REQUEST FOR INFORMATION (RFI)

PROJECT :	BKK2	R.F.I. NO. :	523213-01-RFI-AR-0041
TO :	CTA	ATTENTION :	CTA
SUBMITTED DATE:	6-Feb-26	NEED REPLY BY DATE :	13-Feb-26

SUBJECT : Request for Information - Confirm External Paint Color and Technical Specification for Generators Room

SOFFIT FINISHES SCHEDULE

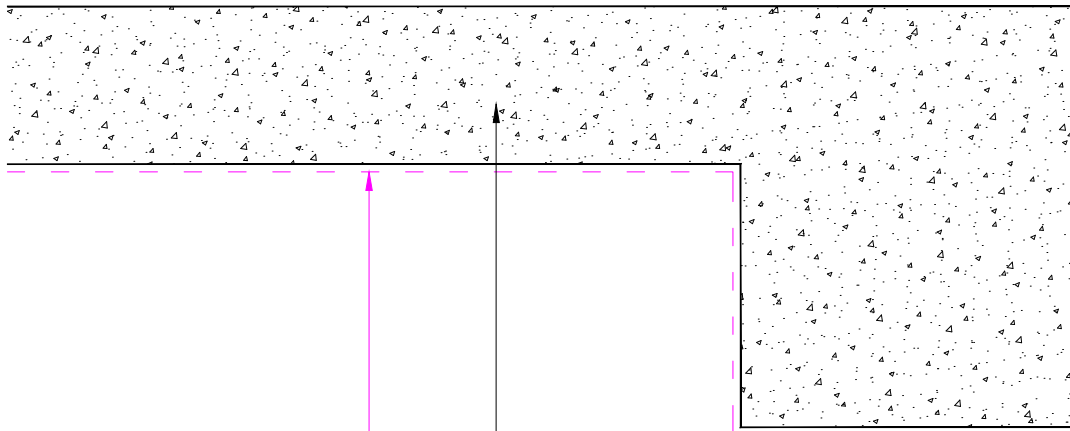
Please provide confirmation on the external paint color and technical specifications for the generator rooms.

**NOTE:**  
- EXTERNAL PAINT COLOUR AND SPECIFICATION FOR GENERATOR ROOMS NEED TO CONFIRM.

SLA: The genset ceiling shall be paint Dark grey RAL 7012
